REMARKS/ARGUMENTS

Claims 1-20 were previously pending in the application. Claims 2 and 18 are canceled; claims 1, 3-17, and 19-20 are amended; and new claims 21-25 are added herein. Assuming the entry of this amendment, claims 1, 3-17, and 19-25 are now pending in the application. The Applicant hereby requests further examination and reconsideration of the application in view of the foregoing amendments and these remarks.

FIG. 2

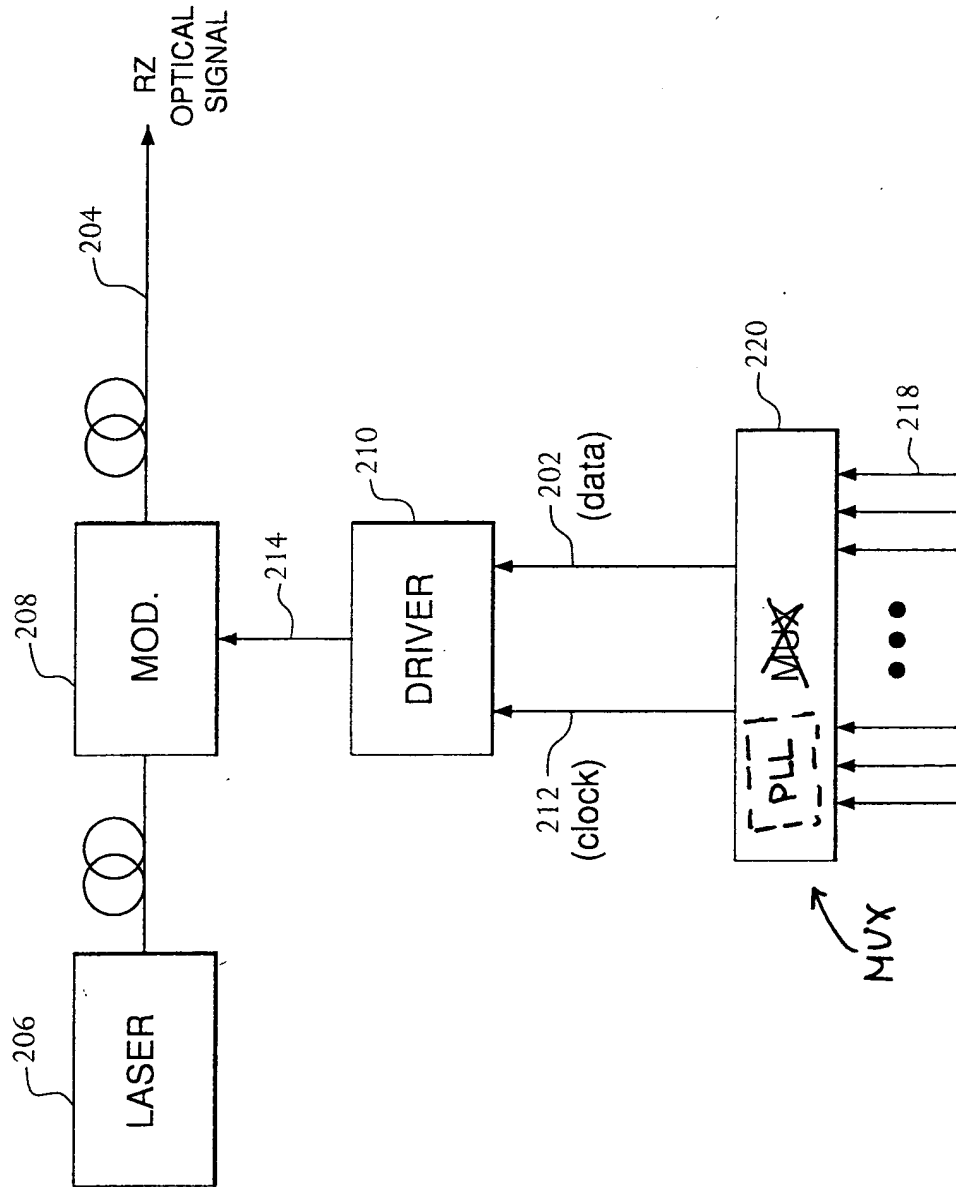
In paragraph 1 of the office action, the Examiner objected to the drawings for not showing every feature specified in the claims. More specifically, the Examiner stated that:

[T]he limitation “the amplifier comprises two or more amplification stages” in claim 8 and “the multiplexer includes a phase-locked loop circuit configured to lock the phase of the clock signal to the trunk NRZ signal” in claim 12 must be shown or the feature(s) canceled from the claim(s). No new matter should be added.

In response, the Applicant submits herewith a Transmittal of Corrected Drawings amending original Figs. 2 and 3 and adding new Fig. 3B. Support for the amendment of Fig. 2 can be found, e.g., on page 3, lines 18-20, and original claim 12. Support for new Fig. 3B can be found, e.g., on page 4, line 32, through page 5, line 5. The specification has been amended to reflect the addition of Fig. 3B and designation of original Fig. 3 as Fig. 3A.
